Subject: REVISION: N232415860-01 - Emission Recall
Fuel Injector Flow Rate Compensation
Revised Service Procedure

Models: 2024 Chevrolet Silverado 2500HD/3500HD
2024 GMC Sierra 2500HD/3500HD
Equipped with ENGINE-DIESEL, 8 CYL, 6.6L, DI, V8, TURBO,
DURAMAX, GEN 5, VAR. 1 (RPO L5P)

N232415860 Fuel Injector Flow Rate Compensation

Revision: 01

6444155

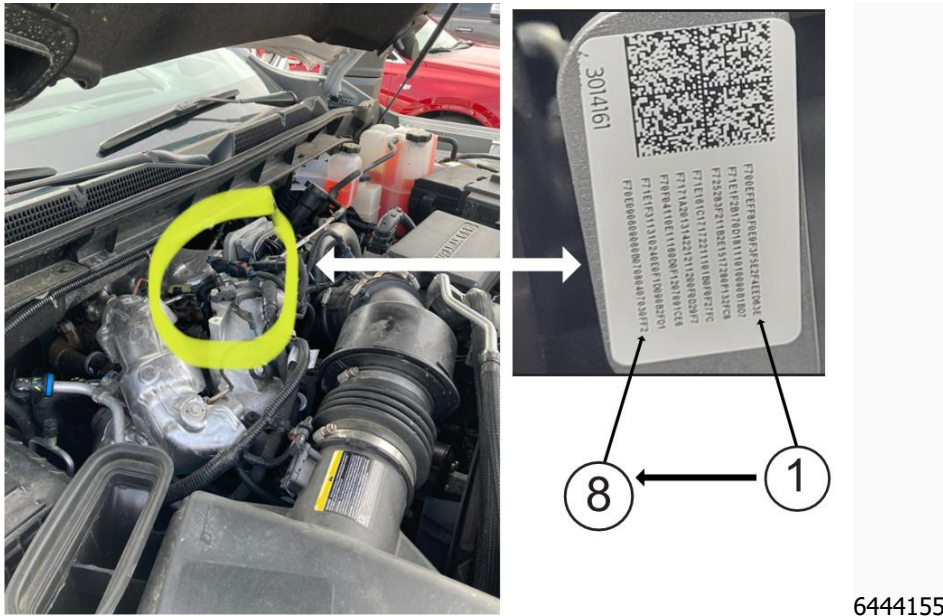
1. Take a picture of the fuel injector label. Starting with injector 1 (1) as shown on the label, the injectors are listed 1-8 consecutively as you go down the label.
